Re: Comments on the Draft Environmental Impact Report

In accord with the February 13, 2009, Notice of Availability of Draft Environmental Impact Report /Statement ("DEIR/EIS") on Southern California Edison Company's (SCE) Tehachapi Renewable Transmission Project ("TRTP" or the "Project"), the City of Chino Hills (the "City" or "Chino Hills") submits the following comments.

COMMENTS ON ALTERNATIVE 4C (modified)

DETAIL DESCRIPTION OF ALTERNATIVE 4C (modified)¹

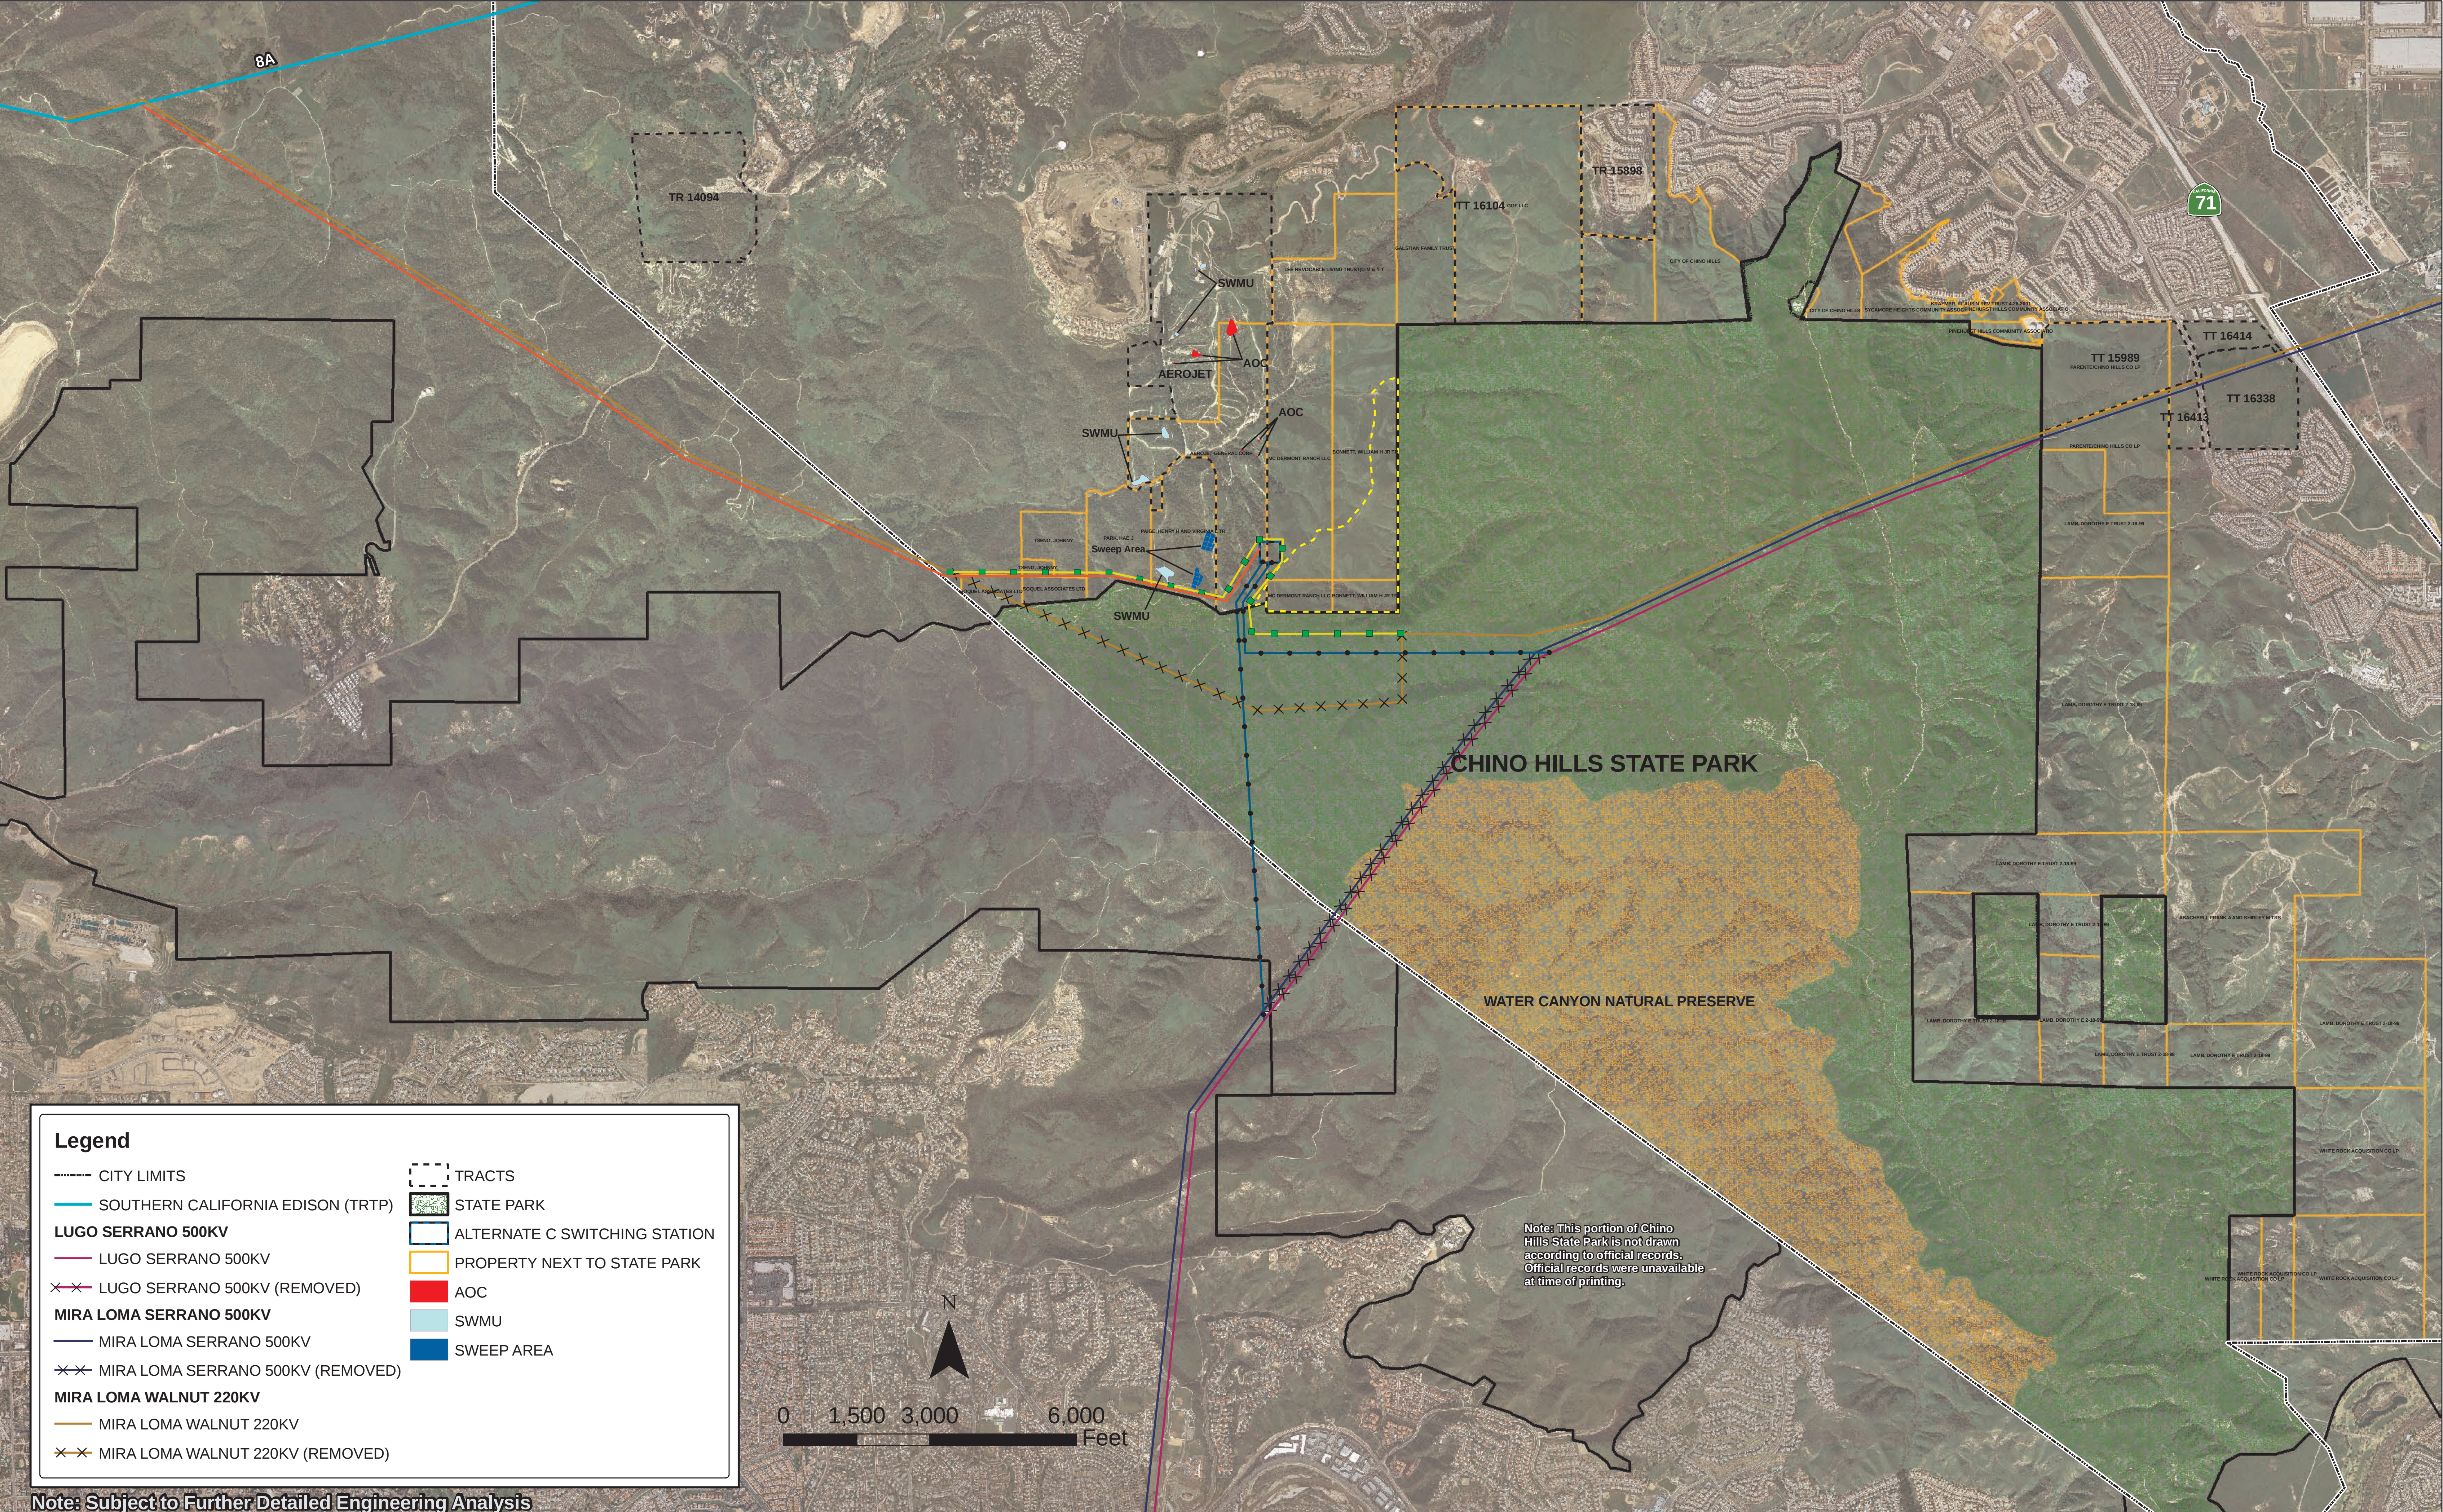
For Alternative 4C (modified), Segment 8A will deviate from the SCE proposed route beginning about two miles east of State Route 57 (approximately S8A MP 19.2), where the existing Mira Loma-Walnut/Olinda 220-kV double-circuit transmission line and the existing unenergized Chino-Mesa transmission line separate from one another. At that point, the new Mira Loma-Vincent 500-kV transmission line will turn southeast, and remain parallel and south of the existing Mira Loma-Walnut/Olinda 220-kV double-circuit transmission line up to 0.3 miles before the Chino Hill State Park (CHSP) boundary (approximately 3.9 miles). Along this portion of the alignment, approximately 150 feet of additional ROW will be required to accommodate the new 500-kV double-circuit structures. At this point, the alternative route will turn east along a new approximately 300 foot-wide ROW for approximately 0.9 miles, which will remain north of the CHSP boundary to a point where it will turn northeast and travel for about 0.2 miles into a new 500-kV gas-insulated switching station. Approximately 17 double-circuit 500-kV Lattice Steel Structures (LSTs) will be required for this approximately 5.0 mile re-route to the new switching station.

LSTs of the existing 500-kV single-circuit transmission lines will be permanently removed from the CHSP (approximately 3.4 miles of 500-kV single-circuit transmission lines).

A portion of the existing 220-kV transmission lines within CHSP will also be re-routed as part of this alternative. This will also take 7 of the existing 220-kV transmission lines from the CHSP, all from ridge tops. Beginning approximately 0.3 miles northwest of the CHSP boundary (outside of CHSP), the existing 220-kV double-circuit structures will be re-routed away from the CHSP to parallel the new Mira Loma-Vincent 500-kV transmission line (Segment 8A) structures north of the CHSP boundary for about 0.9 miles and then northeast for 0.2 miles to the new switching station (approximately 1.1 miles in total to the switching station). As noted earlier, the new ROW for the entire 1.1 miles will be approximately 300-feet wide to accommodate the 500-kV double-circuit and 220-kV double-circuit structures. The 220-kV transmission line will continue past the switching station (will not enter the station), and then turns southwest right after the switching station paralleling the re-routed Serrano-Lugo/Mira Loma 500-kV double-circuit transmission lines for approximately 0.2 mile to the boundary of CHSP. At this point, the re-routed 220-kV transmission line will enter CHSP in a southern direction and travel for approximately 0.1 miles inside the CHSP before turning east. For these 0.3 miles, the 220-kV transmission line will be within the 500 ft ROW mentioned above. The eastward travel of the 220-kV transmission line is about 0.6 miles and makes the line reconnect with the existing 220-kV double-circuit structure within the CHSP just south of the Raptor Ridge. To complete the approximately 1.7-mile 220-kV re-route, approximately 10 new double-circuit 220-kV LSTs will be required (approximately 4 will be within CHSP. Approximately 7 existing 220-kV double-circuit LSTs within CHSP (1.9 miles) and 2 outside CHSP (9 structures in total for 2.2 miles in total) will be removed.

Exhibit

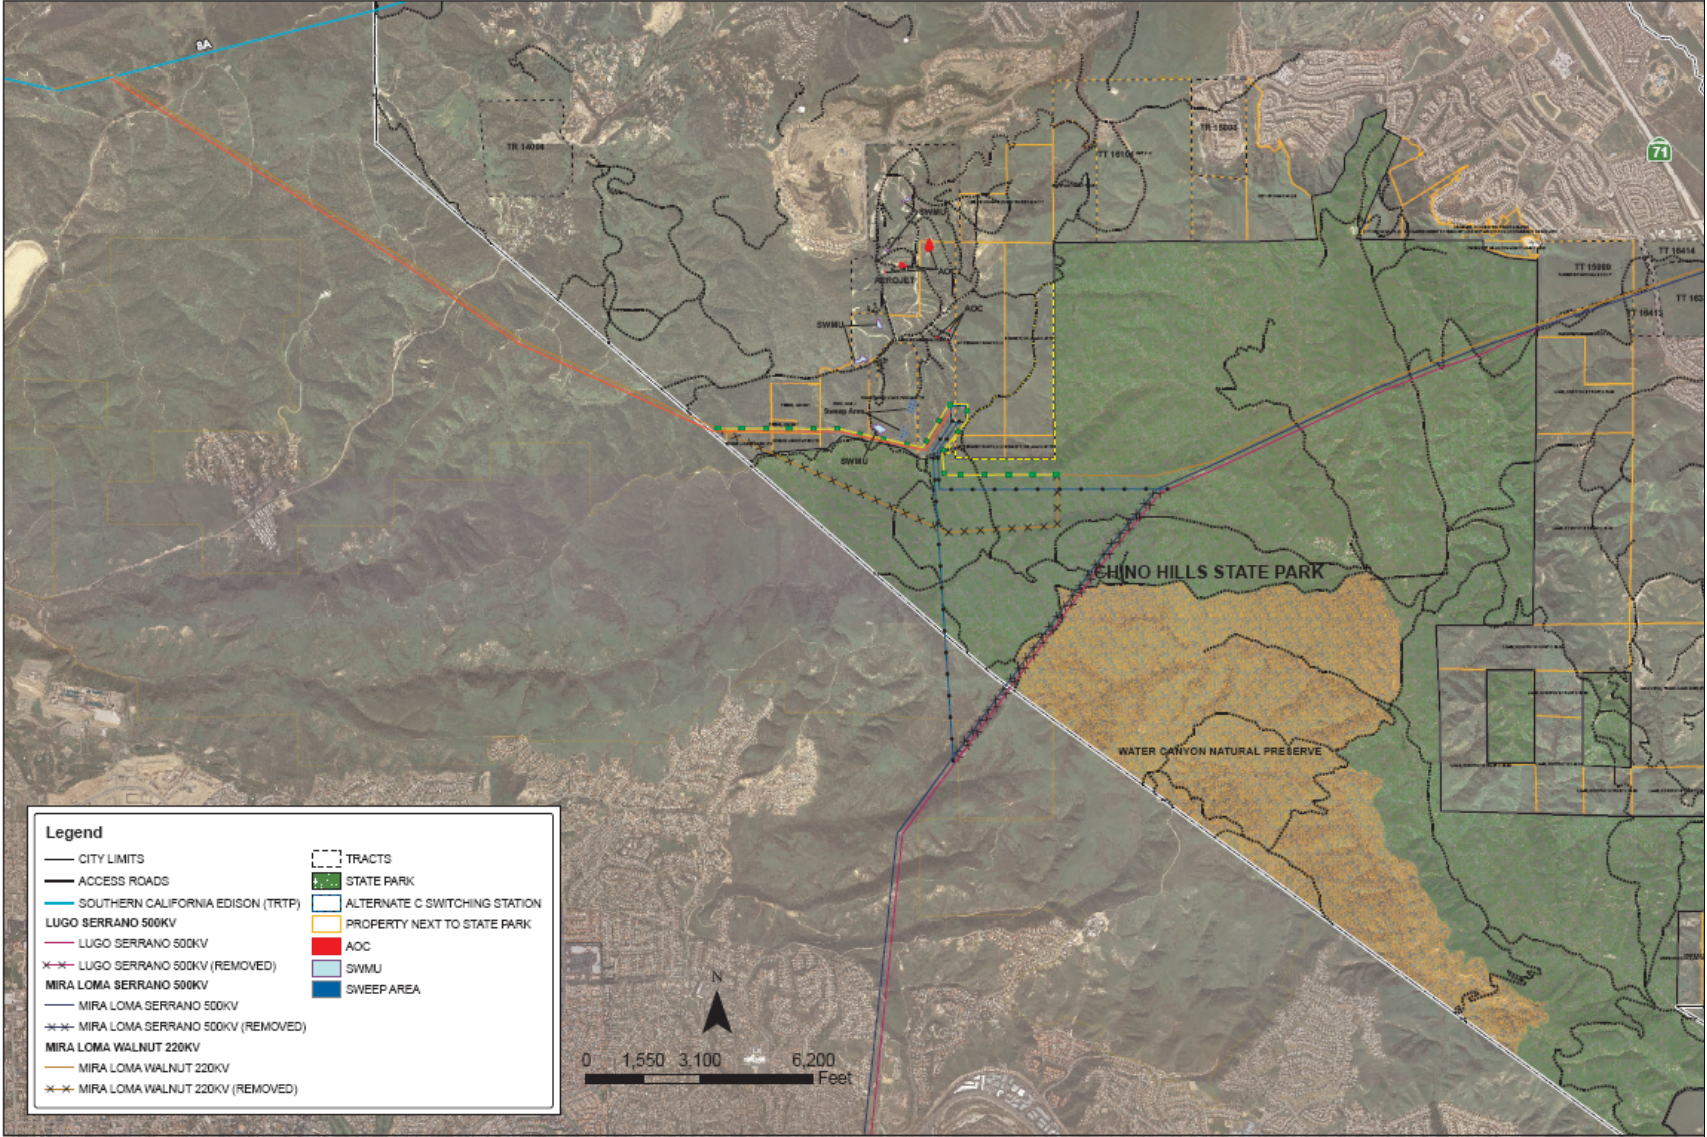
The proposed Alternative Route 4C (modified) effecting the re-routed 220KV and new 500KV transmission lines (assuming a 250-foot corridor), as shown in Exhibit 1, which run from the switching station through the southern portion of the Aerojet property and adjoining leased areas, do not travel through any area that has been found to be contaminated with MEC. This includes the re-routed 500KV line that runs from the south, through the Chino Hills State Park, to the switching station. The lone exception is the path of the re-routed 220KV and re-routed 500KV transmission lines that run from the Bonnett property through the McDermont property connecting with the switching station. The McDermont property portion, which the transmission lines will travel through, was swept and cleared and a number of small items were encountered i.e., fragmentation and one 30mm Target Practice (TP) cartridge. Neither of the items contains any reactive components, therefore the area is not considered to be hazardous. Based on the fact that the area has been previously cleared and that the items encountered posed no hazard, there is no need to re-sweep the area.
